INVITATION TO BID 2022-02
CITY OF PARKER
CITY-WIDE STORMDRAINS SYSTEM IMPROVEMENTS

ADDENDUM NO. 2
REQUESTS FOR INFORMATION

Issued March 30, 2022

Sheet No.
C1.1

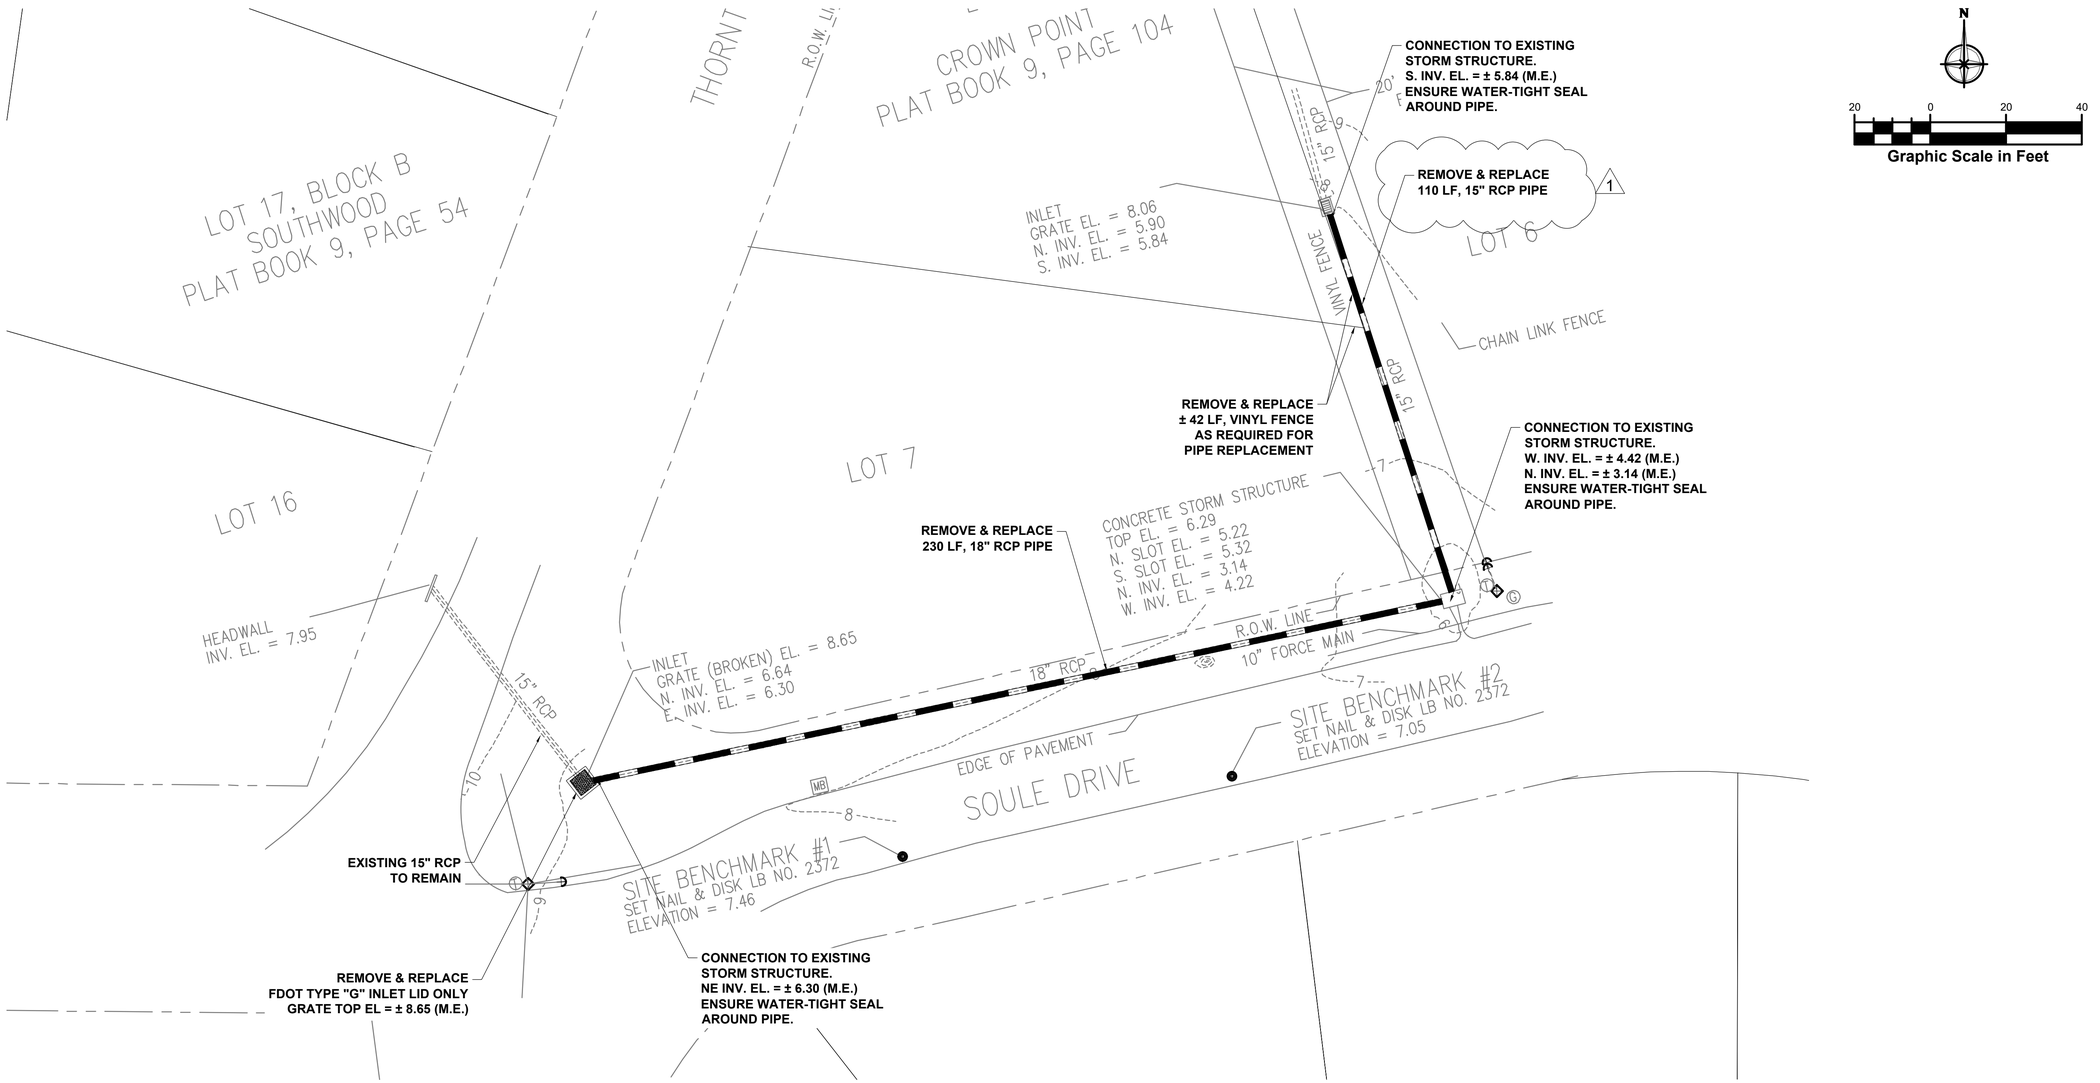
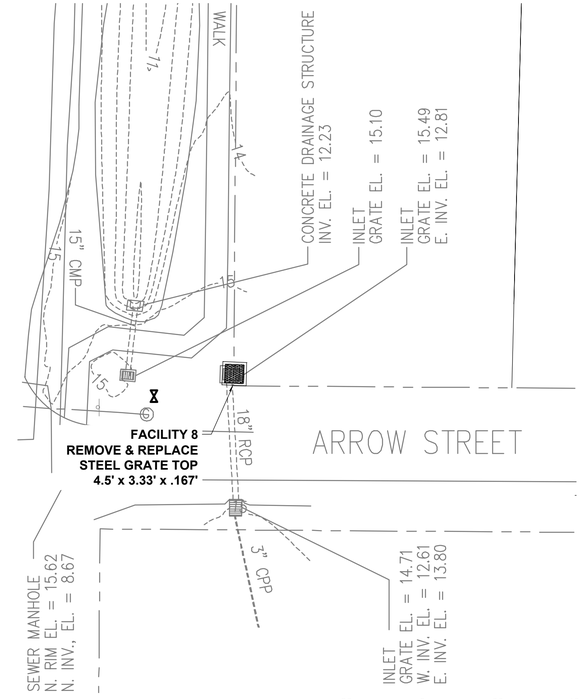
1. **SHEET C1.1 (North Lakewood Drive):** There appears to be a discrepancy in pipe sizes on the drawing and the Bid Form. Sheet C1.1 states existing 42 inch but Bid Form states to replace with 48 inch.

City's Response to Request for Information Question No. 1
   SHEET C1.1 of the Bidding Drawings and references made in the Bidding Specifications have been modified to show replacement of 32 linear of 42-inch RCP to match the existing pipe. The alternate bid has been modified to show relining of approximately 633 linear feet of 42-inch RCP (CIP). Refer to revised SHEET C1.1 of the revised plan set (***Attachment A***), revised Instruction to Bidders (***Attachment B***), revised Bid Form (***Attachment C***), and revised Measurement and Payment (***Attachment D***).

Sheet No.
C1.2

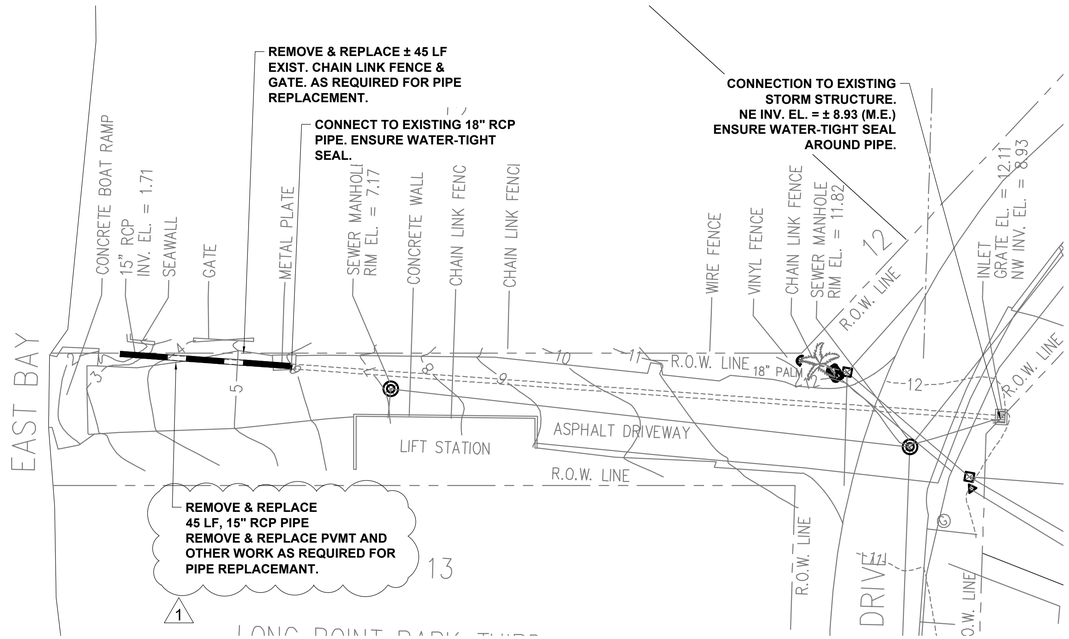
2. **SHEET C1.2 (5301 Soule Drive):** There is a 15-inch reinforced concrete pipe (RCP) in place now that needs to be removed and replaced with 18-inch Corrugated Metal Pipe (CMP)? Does that need to be 18-inch RCP, and if so, the storm structure it ties into will also have to be reconfigured to fit 18 inches instead of 15 inches.

3. **SHEET C1.2 (5301 Soule Drive):** Also, it states to remove and replace 230 linear feet of the 18-inch RCP pipe, but it is actually 15-inch RCP that exists now instead of the 18-inch.

City's Response to Request for Information Question No. 2
   SHEET C1.2 of the Bidding Drawings and references made in the Bidding Specifications have been modified to show replacement of 110 linear feet of 15-inch RCP to match the existing pipe. Refer to revised SHEET C1.2 of the revised plan set (***Attachment A***), revised Instruction to Bidders (***Attachment B***), revised Bid Form (***Attachment C***), and revised Measurement and Payment (***Attachment D***).

City's Response to Request for Information Question No. 3
   As indicated on the drawings, the existing 18-inch RCP will be replaced with approximately 230 linear feet of 18-inch RCP within that area.

253070-14 - BLACKSHEAR DRIVE
SCALE: 1" = 20'

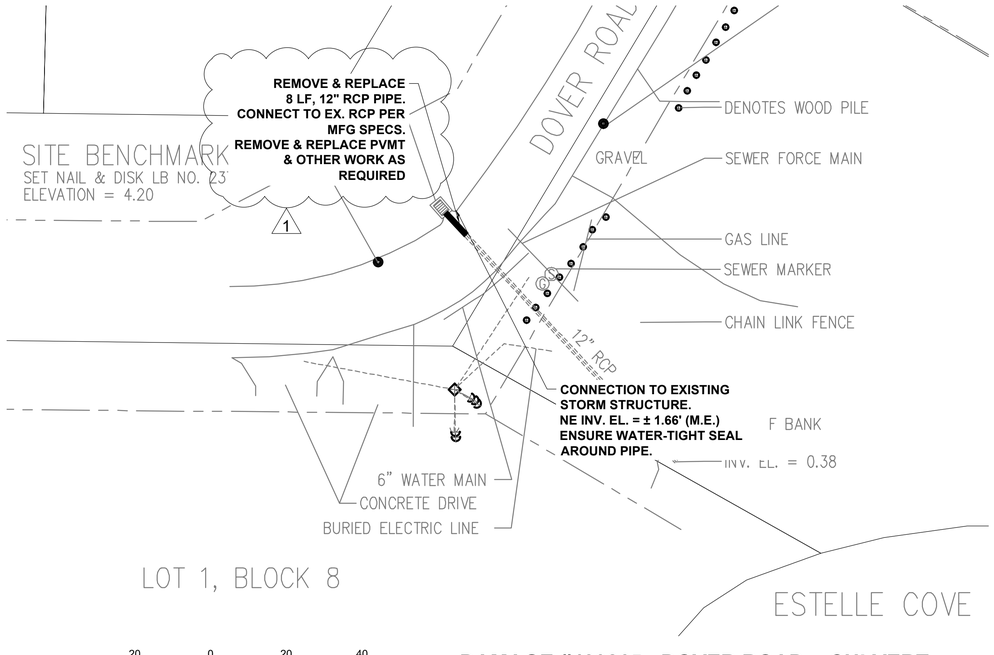
5. **SHEET C1.3 (Blackshear Drive):** You can't replace 45 linear feet of existing 15-inch RCP with 18-inch RCP without reconfiguring the entire structure.

City's Response to Request for Information Question No. 5
SHEET C1.3 of the Bidding Drawings and references made in the Bidding Specifications have been modified to show replacement of 45 linear feet of 15-inch RCP to match existing pipe. Refer to revised SHEET C1.3 of the revised plan set (***Attachment A***), revised Instruction to Bidders (***Attachment B***), revised Bid Form (***Attachment C***), and revised Measurement and Payment (***Attachment D***).

DAMAGE #439865 - DOVER ROAD - CULVERT
SCALE: 1" = 20'

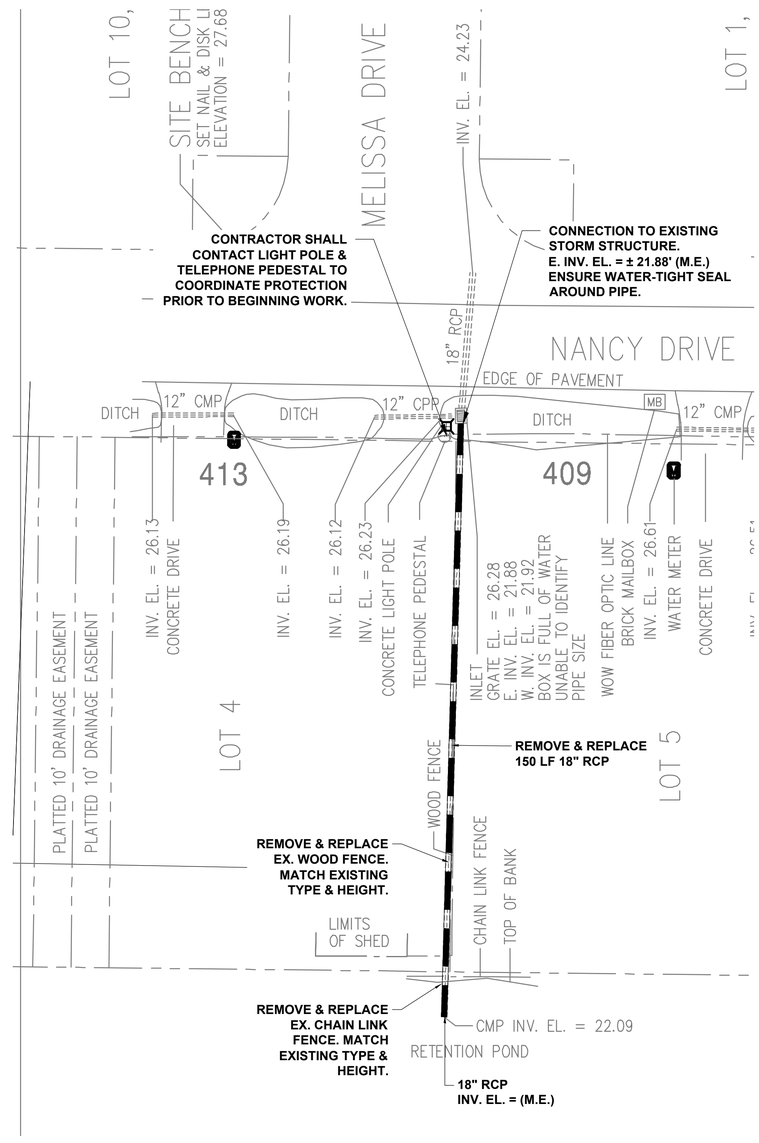
4. **SHEET C1.3 (Dover Road Culvert):** You can't replace 8 linear feet of 18-inch RCP without reconfiguring the entire structure because of the existing 12-inch RCP.

City's Response to Request for Information Question No. 4
SHEET C1.3 of the Bidding Drawings and references made in the Bidding Specifications have been modified to show replacement of 8 linear feet of 12-inch RCP to match existing pipe. Refer to revised SHEET C1.3 of the revised plan set (***Attachment A***), revised Instruction to Bidders (***Attachment B***), revised Bid Form (***Attachment C***), and revised Measurement and Payment (***Attachment D***).
